SUBJECT: COMANCHE PEAK NUCLEAR POWER PLANT, UNITS 3 AND 4
DOCKET NUMBERS 52-034 AND 52-035
RESPONSES TO REQUESTS FOR ADDITIONAL INFORMATION NO. 2828 AND 3698

Response to Request for Additional Information No. 2828 (CP RAI #124)

Response to Request for Additional Information No. 3698 (CP RAI #109)

SRP SECTION: 09.02.01 - STATION SERVICE WATER SYSTEM

Figure 9.02.01-1

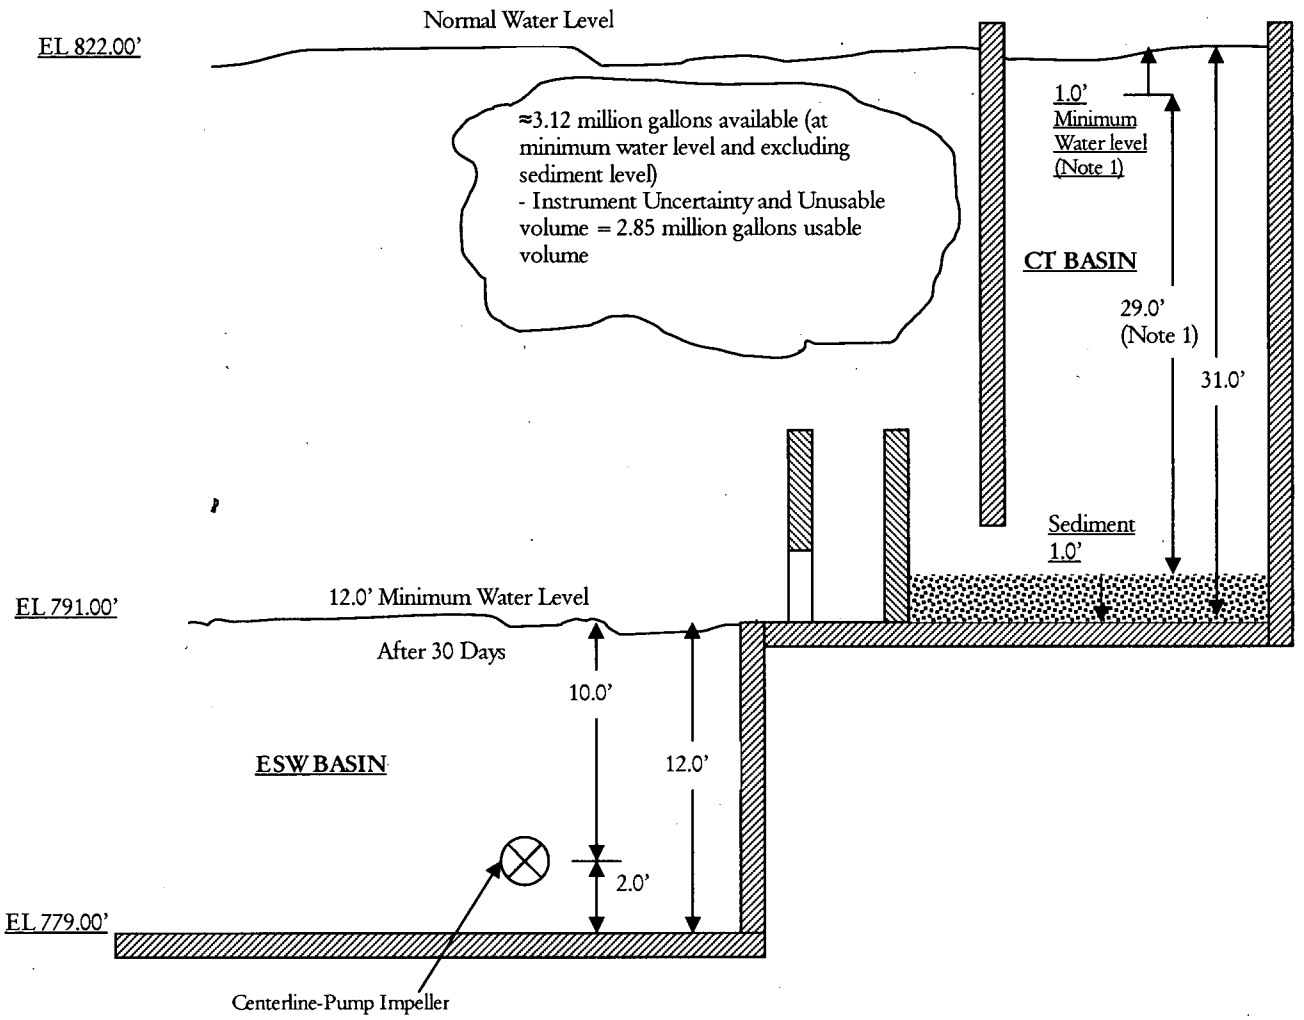
US-APWR Design Control Document (DCD) COL 9.2 (1) requires the COL Applicant to provide the evaluation of the ESWS pump(s) at the lowest probable water level in the ultimate heat sink (UHS). DCD COL 9.2 (6) specifies that the COL Applicant should provide the ESWP design details including required total dynamic head and net positive suction head (NPSH) available. The ESWS pumps are important components used in part for heat transfer to satisfy GDC 44, and adequate ESWS pump performance including required NPSH for the ESWS pumps needs to be considered as part of the system design. For the above reasons, the NRC staff requests the applicant to provide the following information related to GDC 44 and NSPH consideration:

- Discuss pump vortex formation as part of the NPSH evaluation.
- Provide drawings indicating the elevation of the ESWS pump impellers..
- Include in the FSAR the low water level in the UHS to support adequate NPSH.
- Include in the FSAR the NPSH instrumentation for minimum water level to assure ESWS operability.
- Add the minimum water level to the Technical Specifications (TS), Section 3.7.9, "Ultimate Heat Sink," Surveillance Requirements. The TS currently addresses the total volume of 10.7 million liters (2,850,000 gallons) and approximate level of 12.2 meters (40 feet).

The attached Figure 9.02.01-1 depicts UHS water levels of interest. As noted in FSAR Section 9.2.5, each cooling tower structure consists of the cooling tower (CT) basin located underneath the tower. The Essential Service Water (ESW) intake basin, located underneath the ESW pump house, is adjacent to the CT basin. Both basins are interconnected and maintain the same water level. The CT basin floor elevation is 791 ft. The ESW intake basin floor elevation is 779 ft. The ESWS pump (located in the intake basin) impeller (eye) is located approximately at elevation 781 ft. A vaned basket is installed at the suction of the vertical ESW pump. FSAR Figure 3.8-209 provides a typical section view of the UHS basin including the ESWS pump elevation.

A normal water level of approximately 31 feet above the CT basin floor (822 ft elevation) is maintained during plant operation. This provides a water level of 43 feet in the pump intake basin. Following a design basis accident, water level in the pump intake basin after 30 days without makeup will be approximately 12 feet. The ESW pump is located approximately 10 feet from the basin wall. The UHS transfer pump and the ESW pump from the same basin do not operate simultaneously. Thus the pump submergence, location, and operating restrictions preclude any vortex formation.

As noted above, following a design basis accident, water level in the pump intake basin after 30 days without makeup will be approximately 12 feet.

Available NPSH is computed as follows:

NPSHA = atmospheric pressure + static head – pressure drop through suction piping - vapor pressure corresponding to water temperature of 95 deg. F at pump suction

= (14.3 x 2.31 / 0.995) ft + 10 ft (water level elevation – impeller eye elevation) – 0.0 – 1.88 ft

= 41.32 ft

Figure 9.02.01-2, Excerpt from FSAR Figure 9.2.1-1R

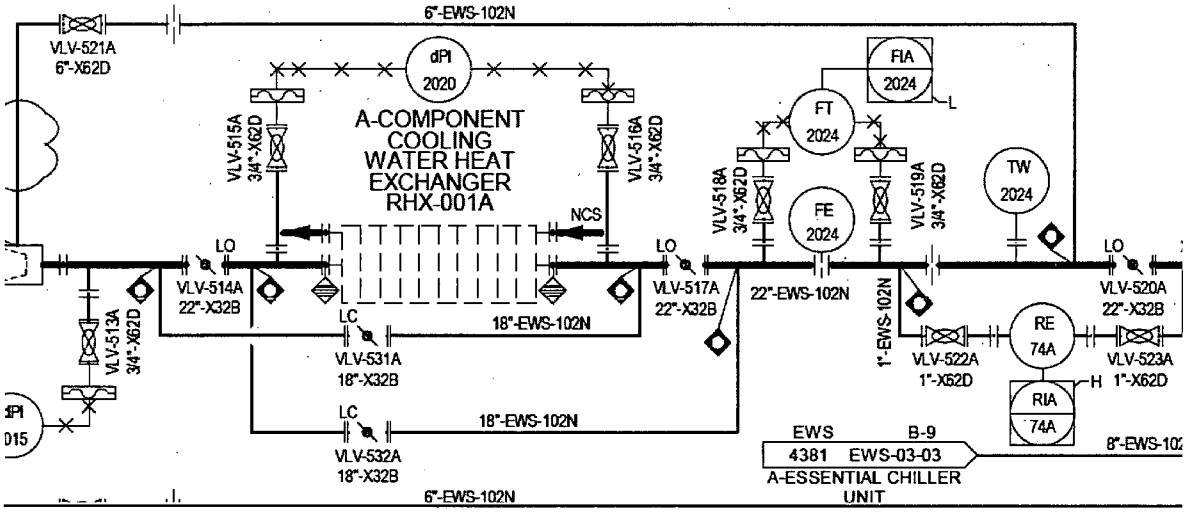
B. The concept of maintaining locked open valves (which are also shown on FSAR Figure 9.2.1-1R, "Essential Service Water System Piping and Instrumentation Diagram") adequately addresses the possibility of over pressurization. However, when these valves are closed for heat exchanger backflush, over pressurization was not adequately addressed by the applicant. Provide a discussion in the FSAR for the over pressurization protection when the locked open valves are closed for heat exchanger flushing.

B. The CCW heat exchanger back flush operation is described in DCD Subsection 9.2.1.2.2.6. The self-cleaning strainer located at each heat exchanger inlet minimizes clogging and need for back flushing. All valves around the CCW heat exchanger are administratively controlled.

Back flush operation for a typical train (A) is as follows (refer to the attached Figure 9.02.01-2). Heat exchanger (HX) inlet and outlet isolation valves VLV-514A and VLV-517A are closed and bypass valves VLV-531A and VLV-532A are opened. Water from the inlet of the HX inlet isolation valve VLV-514A flows through the bypass valve VLV-531A and in the HX from the discharge side. The water flows out of the HX from the inlet side to the bypass valve VLV-532A and then to the outlet side of the valve VLV-517A. Thus, the HX is not isolated during back flushing operation; cooling operation is continued and there will not be any overpressurization.

Figure 9.02.01-3, Typical ESWS – FSS Interface

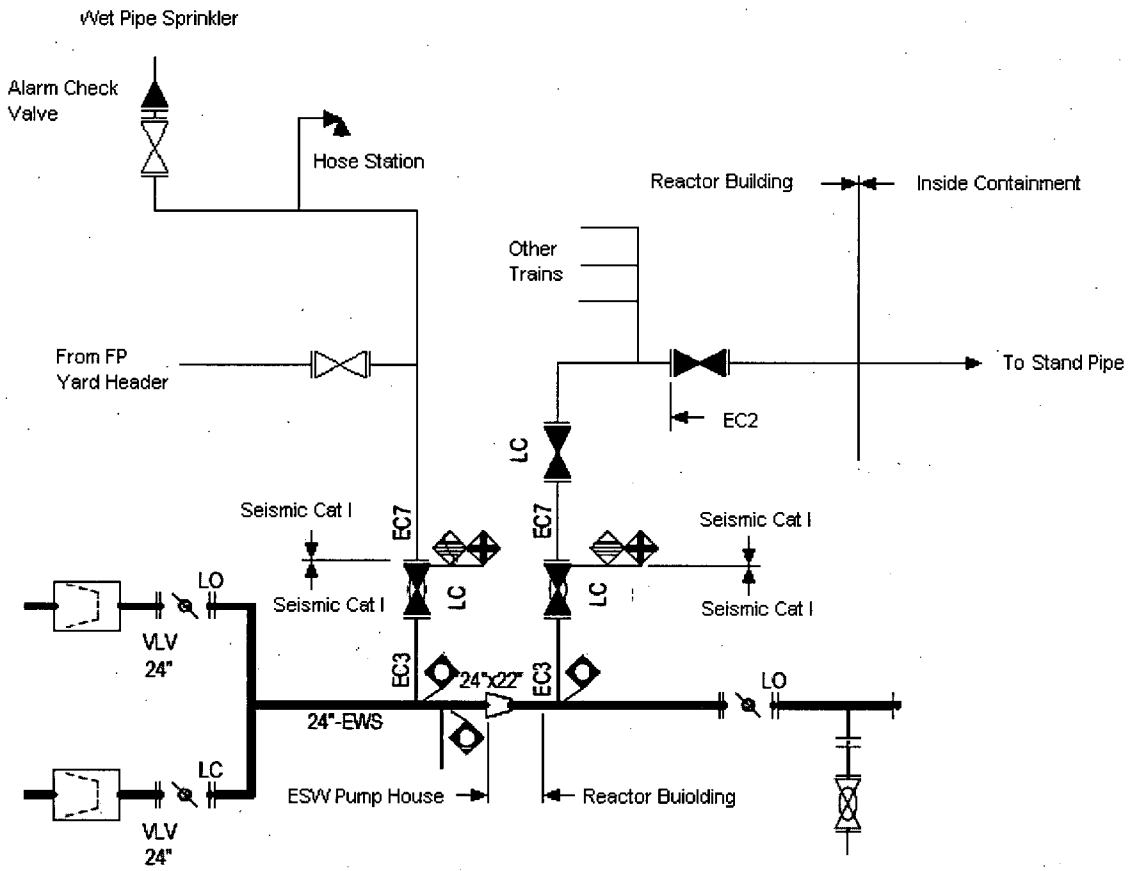
- FSAR Figure 9.2.1-1R, "Essential Service Water System Piping and Instrumentation Diagram," does not graphically show that these normally locked closed (LC) valves are connected to FSS hose stations. Revise FSAR to correctly show a hose or flange connection downstream of the LC valves.

As noted in FSAR Figure 9.2.1-1R, normally locked closed valves are the boundary between the ESWS and the FSS. Attached Figure 9.02.01-3 shows an example of the interface between the ESWS and FSS. Piping downstream of the locked closed, equipment class (EC) 3 ESWS valves, is part of the FSS (EC7 as shown in Figure 9.02.01-3). FSAR Figure 9.5.1-201 will be revised to show the FSS interface with ESWS.
